Technical Bulletin

Bulletin No.: PRO-08-17

Subject: **AD-2 Outlet Port Check Valve Change**

FIGURE 1 -- NEW DESIGN AD-2 OUTLET PORT CHECK VALVE

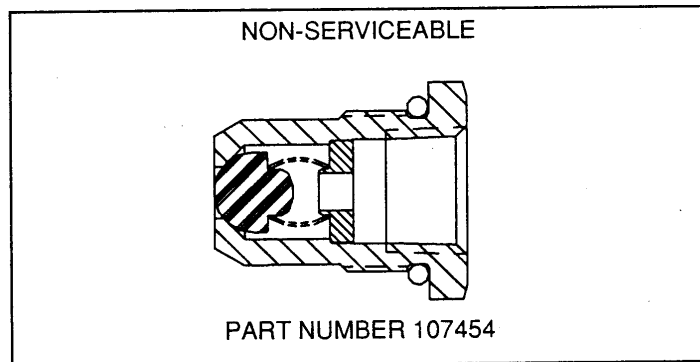
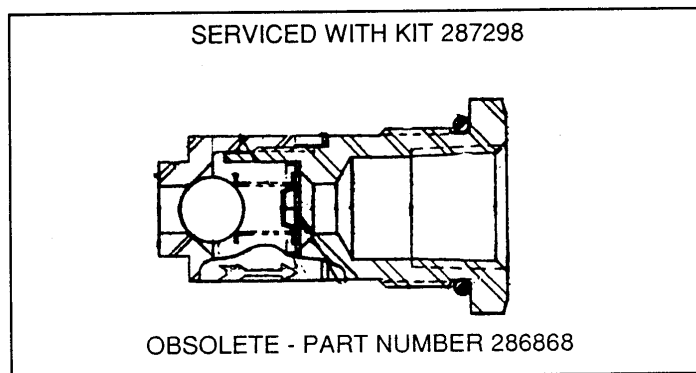
Beginning in March of 1990 Bendix began incorporating a new check valve assembly in the outlet port of all new production AD-2 Air Dryers. The original AD-2 outlet port check valve assembly, part number 286868, is now obsolete and superseded by 107454. No changes were made to the AD-2 shell or check valve outlet port, therefore, both old and new versions of the check valve are interchangeable in the same air dryer.

The primary difference between the old and new check valve assemblies is that the new design check valve, part number 107454, is **NON-SERVICEABLE** and must be replaced as an assembly. The old design check valve, part number 286868, is serviceable using maintenance kit 287298. Maintenance kit 287298 is still available and can be used to service existing 286868 valve assemblies.
